Thank you for contacting the City of Sammamish regarding the current Shoreline Substantial Development Permit Application for East Lake Sammamish Trail Segment 2B (SSDP2016-00415).

**Exhibit 29**  
**SSDP2016-00415**  
**004983**

Regarding: East Lake Sammamish Trail - South Sammamish Segment B 60% Design Plan

Fig # 2

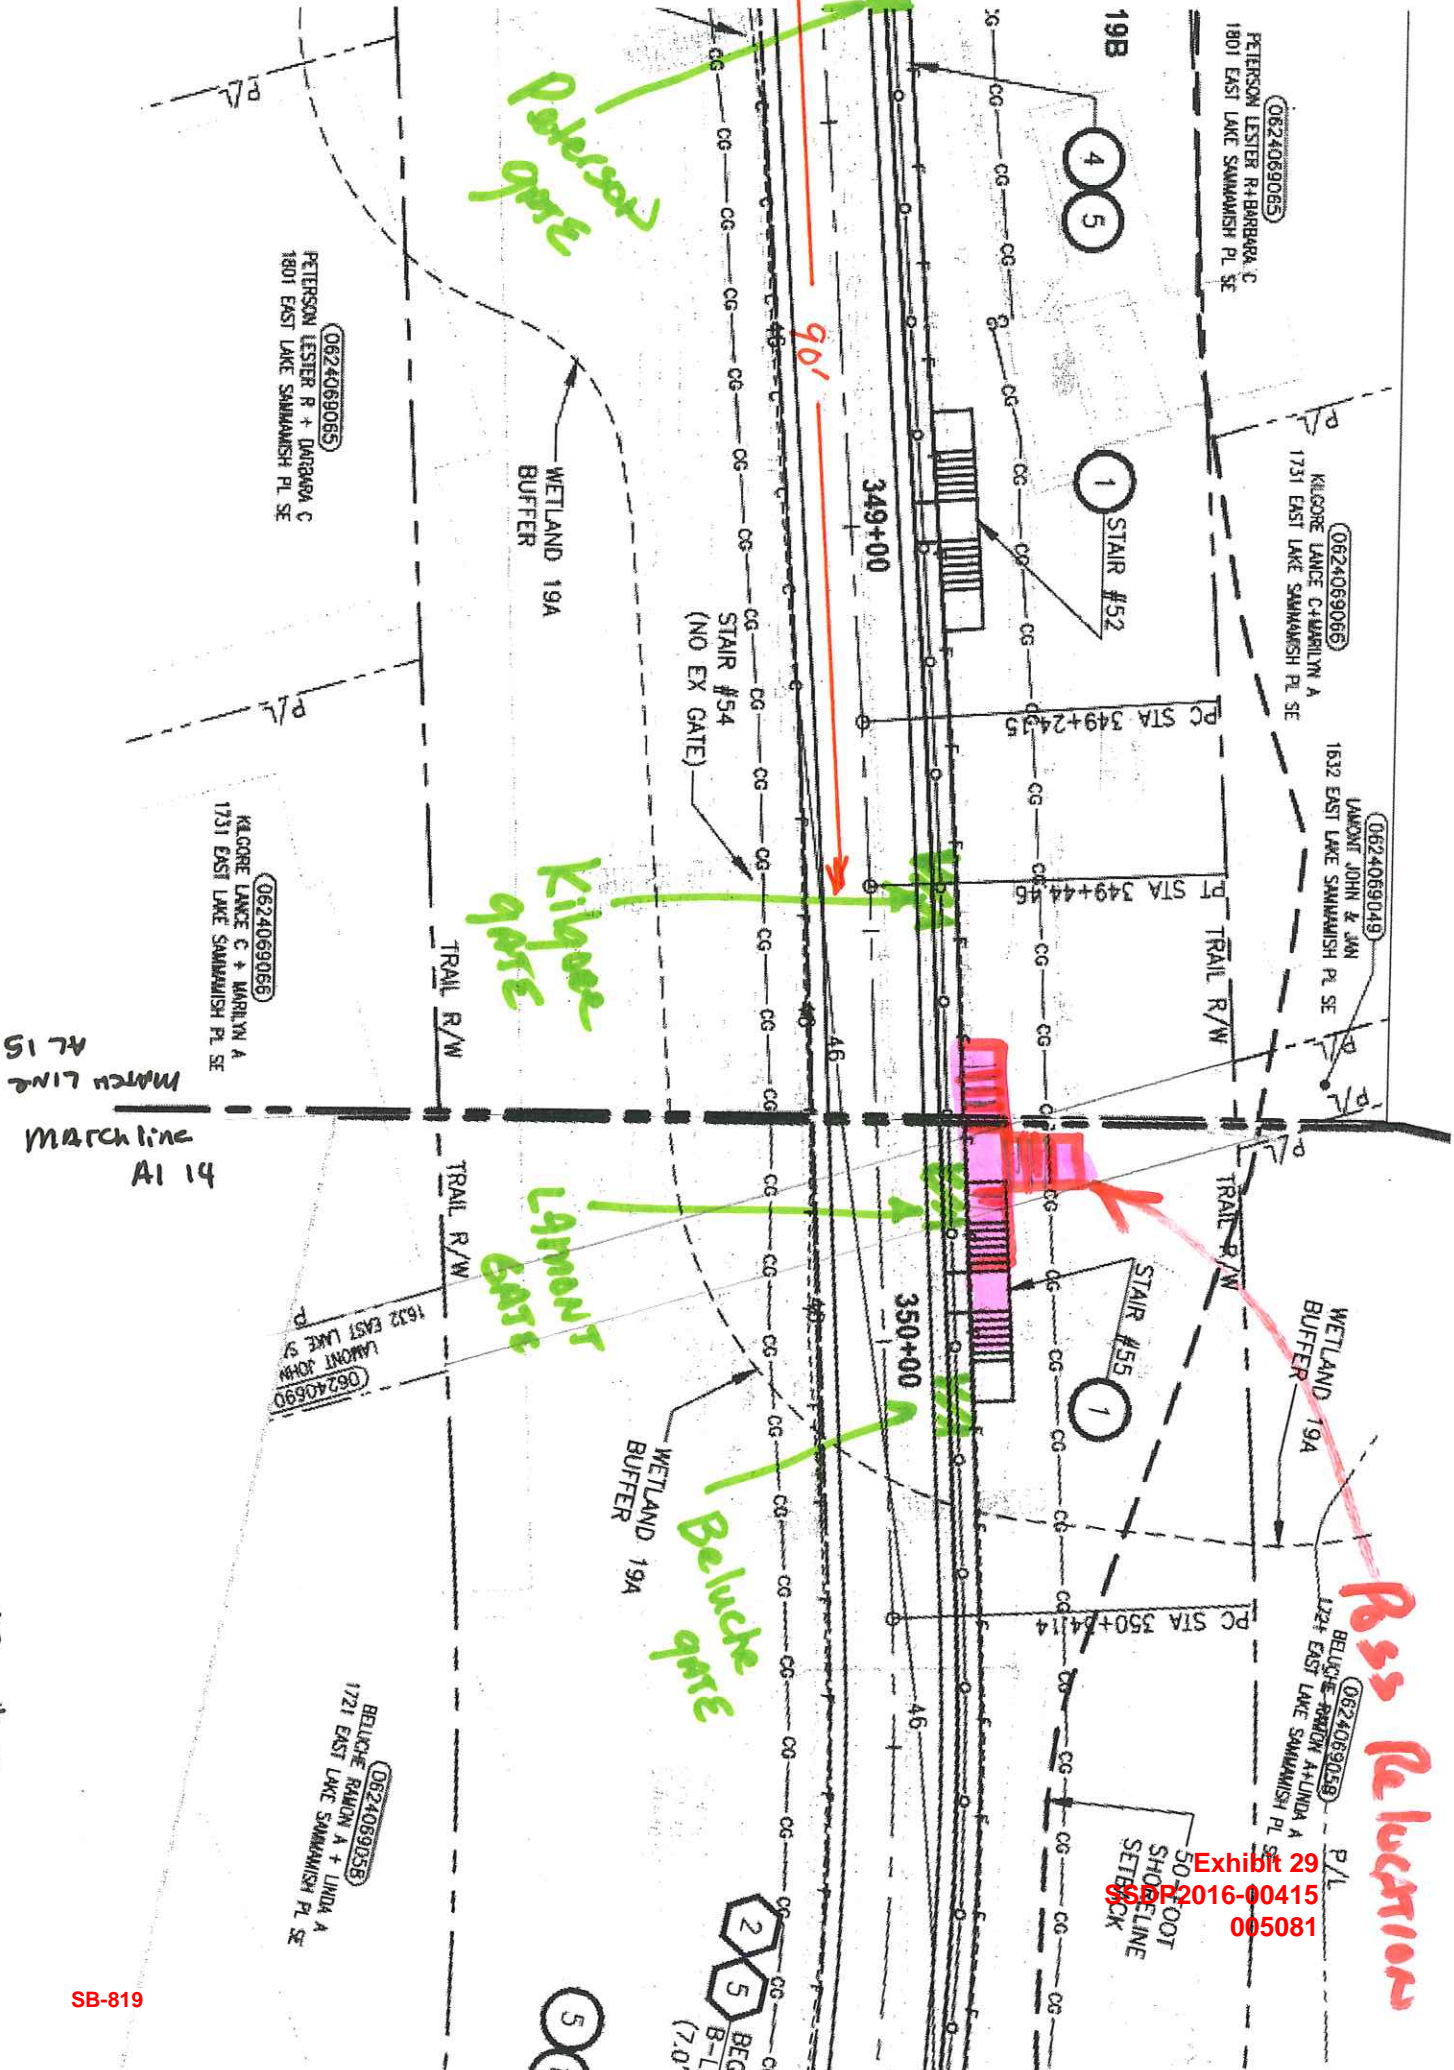
- This location will provide a better crossing point to the respective properties. (See photo 3, fig 2 delineated in red.
- An access gate at this property line would be much closer to the stairs coming down from both residences.

Picture #2

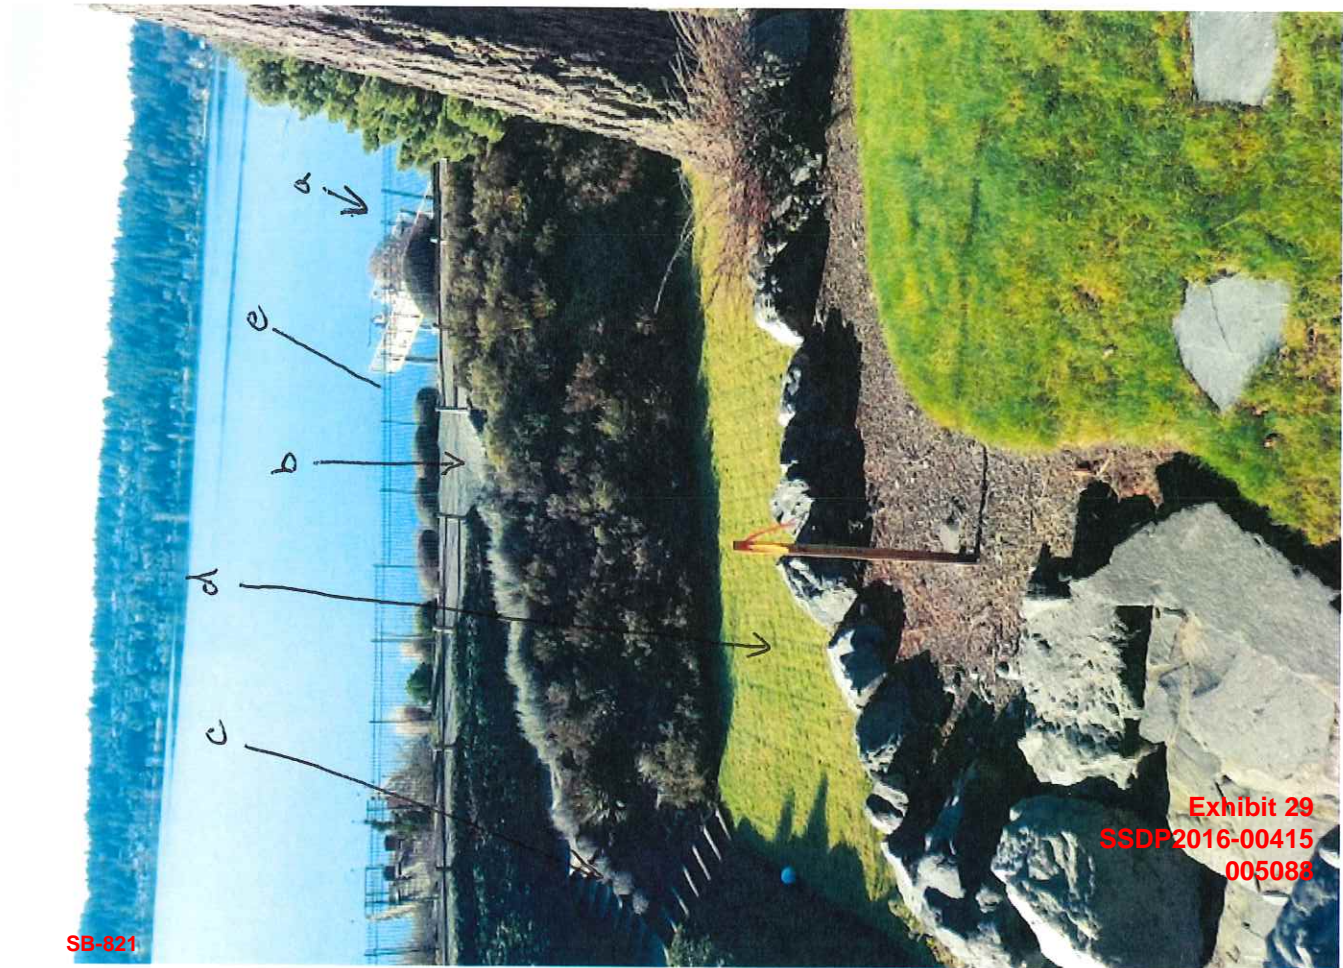
- a. current gate on west side of trail.  
Plan does not replace
- b. gate allowing access to current trail and to gate a to dock.  
Plan does not replace, thereby cutting off access as new fence on eastside has no gate/access.
- c. Stain #36 removed during construction & not replaced?
- d. Aerial view of lower lawn to be 80% replaced with "WBA" (wetland Buffer Addition)!
- e. Current "substantial" fence to be removed with no plan to replace.

Picture #3

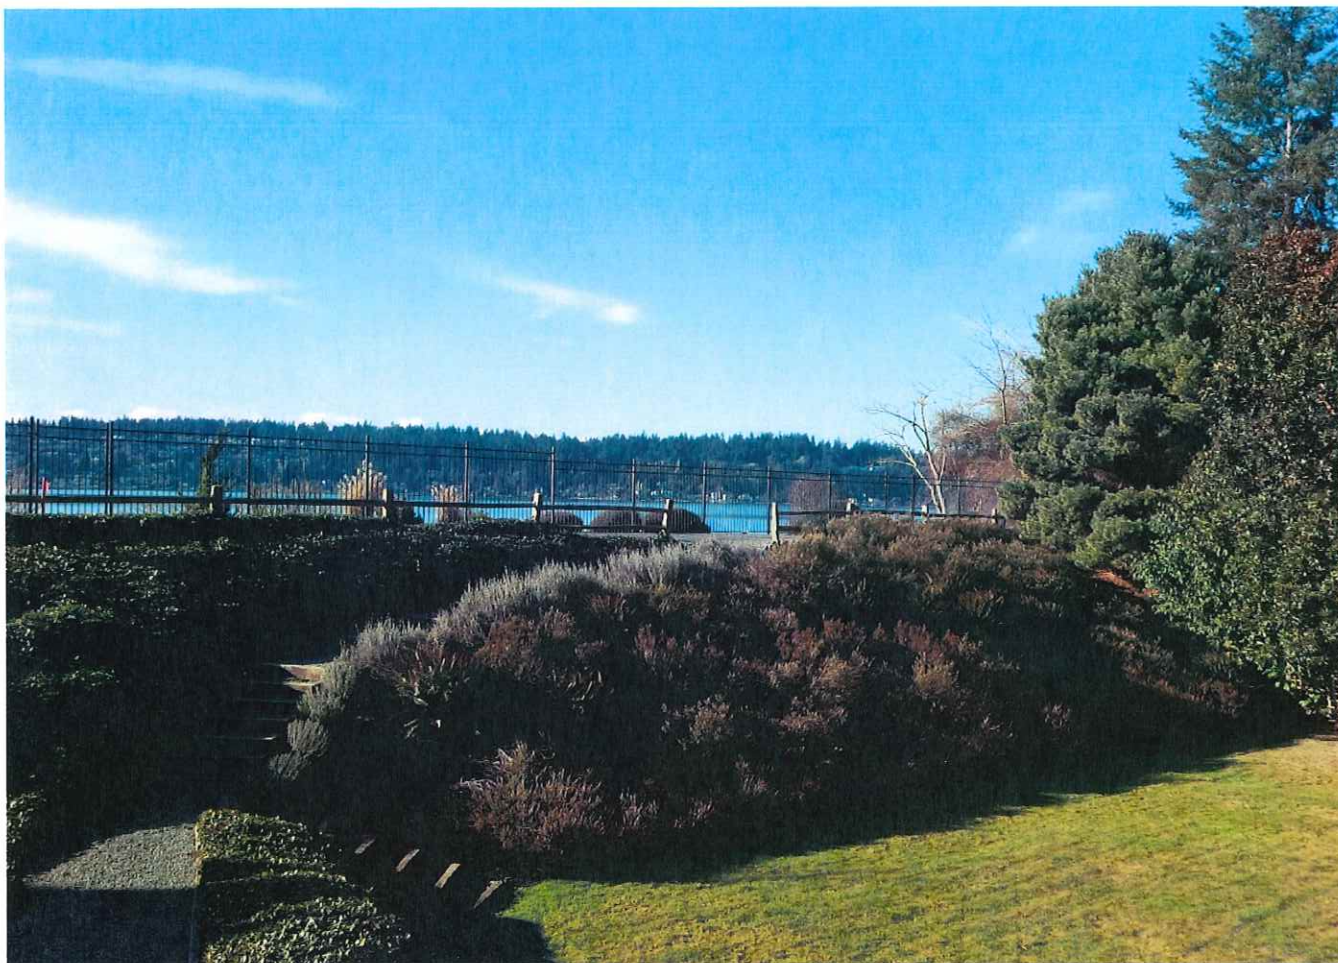
Shows current trail is at grade with fence on west side. Plan calls for removal with no replacement due to need to "clean & grub" 6" to the lakeside of current fence line.

Picture # 10

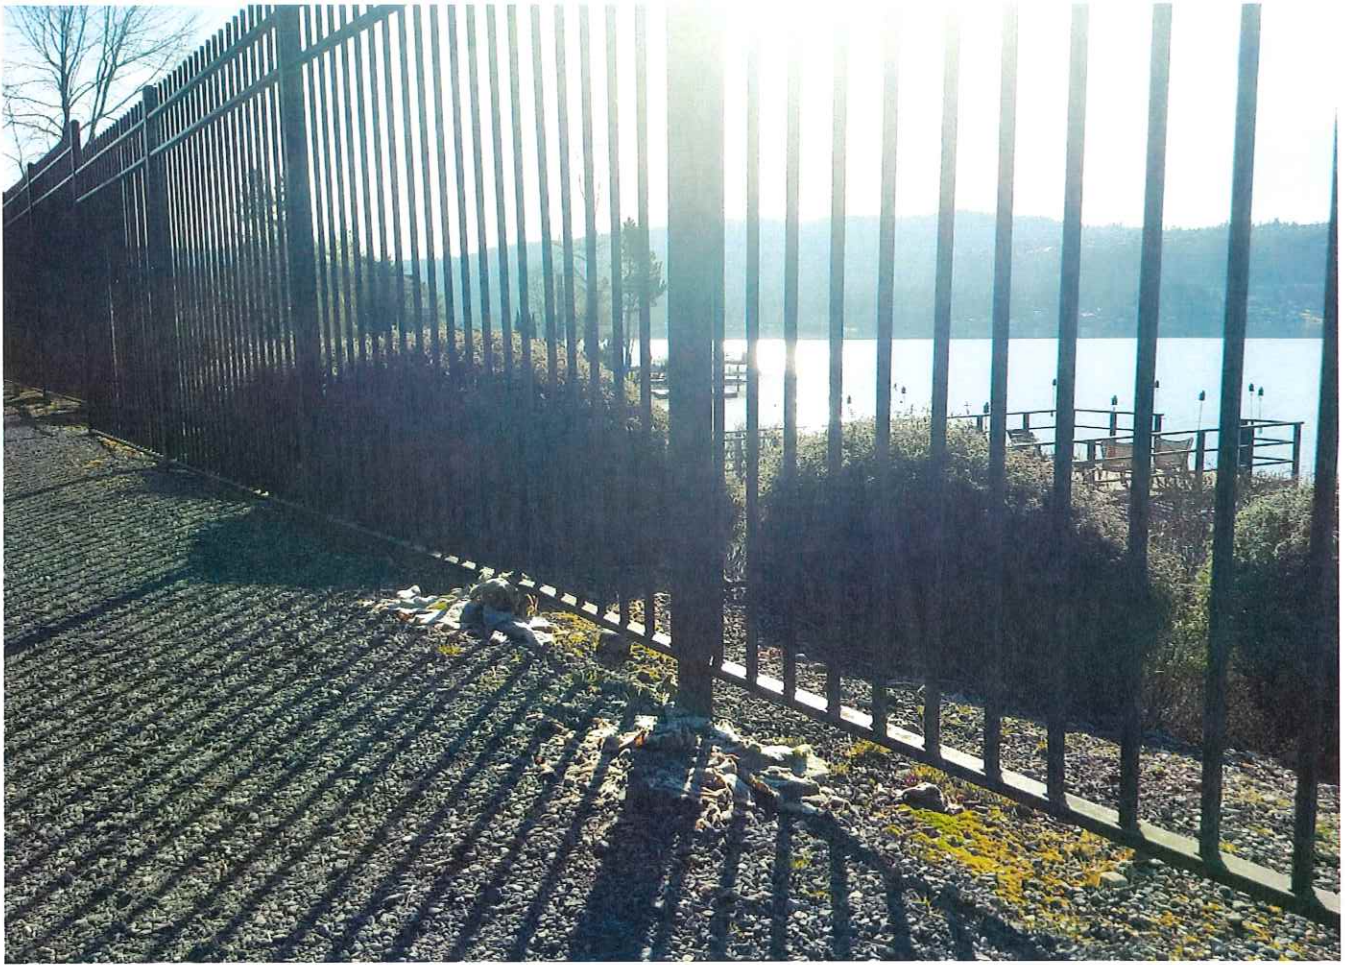
Close up of 700+' of "substantial" fence. Clearly "clearing & grubbing" can be accomplished without the fence's removal. Also indicates that significant erosion is possible if fence is eliminated.
